City of Richmond

Report to Committee Planning and Development Division

Date: February 29, 2016
File: RZ 15-691873

Re: Application by Malkit Johal for Rezoning at 8431 No. 1 Road from Single Detached (RS1/E) to Compact Single Detached (RC2)

TREE MANAGEMENT DRAWING

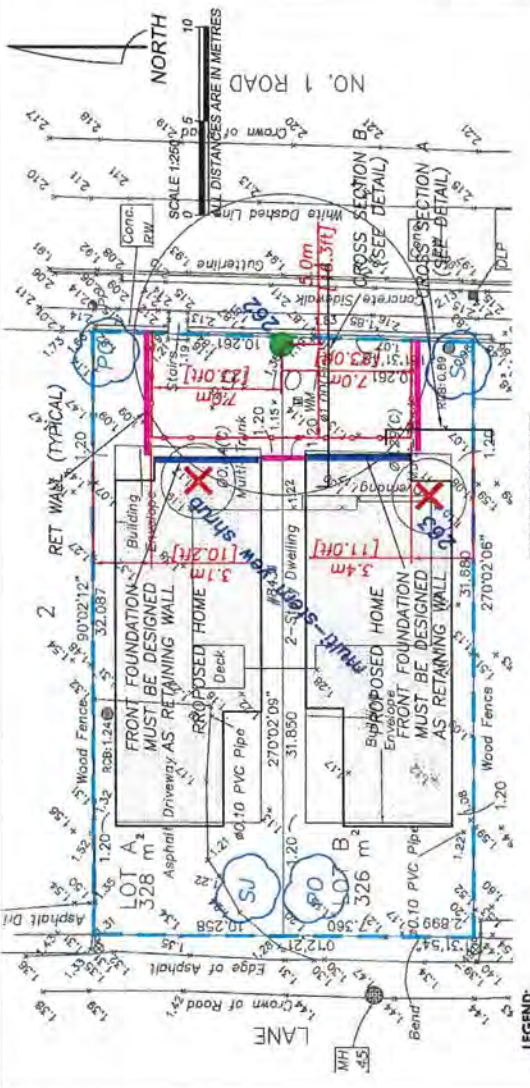
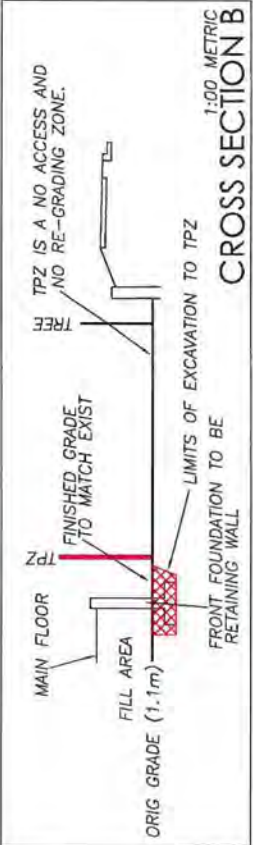
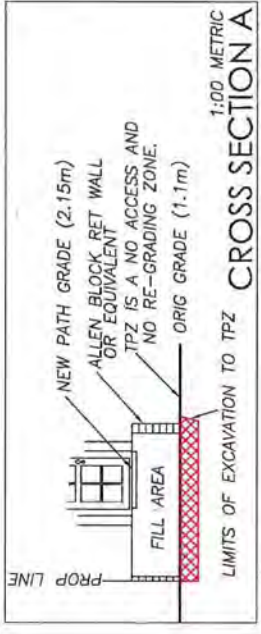
The nature of the concern raised was whether the existing large tree in the front yard of the subject site will be retained with the proposed development. Staff provided a response to the resident, confirming that the tree is required to be retained and protected through the proposed development.

The proposed Tree Retention Plan is shown in Attachment 5. The Plan provides cross-section details showing that the lot grade within the protection zone of Tree # 262 must be maintained at its current elevation and that only small portions of the lot to the north and south of the tree protection zone are proposed to be filled to accommodate pedestrian walkways to the front entries of each dwelling.

Your Name	Karin Holland Biggs
Your Address	12262 Ewen Avenue
Subject Property Address OR Bylaw Number	8431 #1 Road
Comments	<p>This single family property has an application to be rezoned to a 2 family property. I am concerned that the magnificent, unique, 100-150' tree in the front yard near the sidewalk will be cut down, when the property is loaded with sand before building. I believe it is a fir. This would be a criminal loss of an irreplaceably tall and well formed tree which stands visible for kilometres, like a church spire between Francis and Blundell Roads. This "elder" tree, given its maturity and stature, cannot be replaced by some new planting. There is no signage or red protective taping to show the developer intends to protect this tree. I request the city ensure that this tree, which started its life before any of us were born, be protected to continue to grow after we are gone. Dr. Karin Holland Biggs, Ph.D.</p>

To ensure that the front yards of the proposed lots are enhanced consistent with the landscape guidelines of the Arterial Road Policy, and that the lot grading is maintained within the protection zone of Tree # 262 as shown in the Tree Retention Plan, the applicant is required to submit a Landscape Plan for the front yards, prepared by a Registered Landscape Architect, along with a Landscaping Security based on 100% of a cost estimate provided by the Landscape Architect for the proposed works. A portion of the security (e.g. 70%) will be released after construction and landscaping at the subject site is completed and a landscaping inspection by City staff has been passed. The City will retain the balance of the security for a one-year maintenance period to ensure that the landscaping survives.

- Comply with the guidelines of the OCP's Arterial Road Policy and should not include hedges along the front property line.
 - Include the dimensions of tree protection fencing as illustrated on the Tree Retention Plan attached to this report.
